Access Compliance Report Public Rights-of-Way (Curb Ramps)

Main Street: NARROW_CANYON_RD		Cross Street: GAIA_LN		Location:	NW
ADA ID: RPRK211028132112	Ramp Type: Type 1 - Perpendicular	Initial Pass/Fail: Fail	Overall Compliance: No	Severity Score:	2
Codes/Mitigation Info/Possible Solution			Field Measurements/Component Compliance

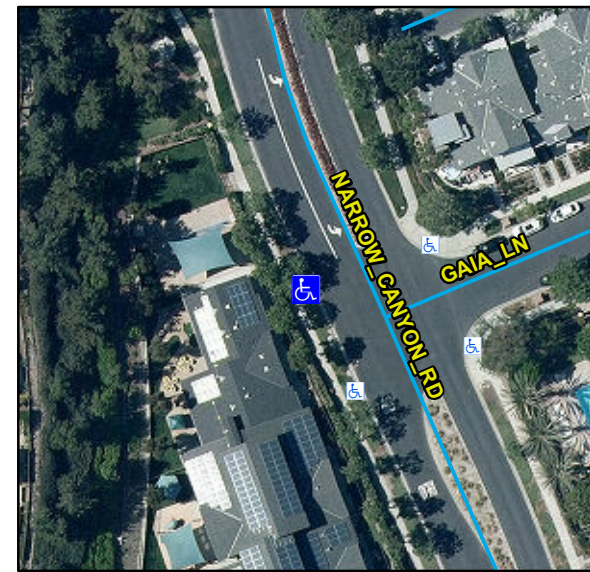
R304.2.2, R204.3, R304.5.3, STD 1115

Remove & Replace Entire Ramp.
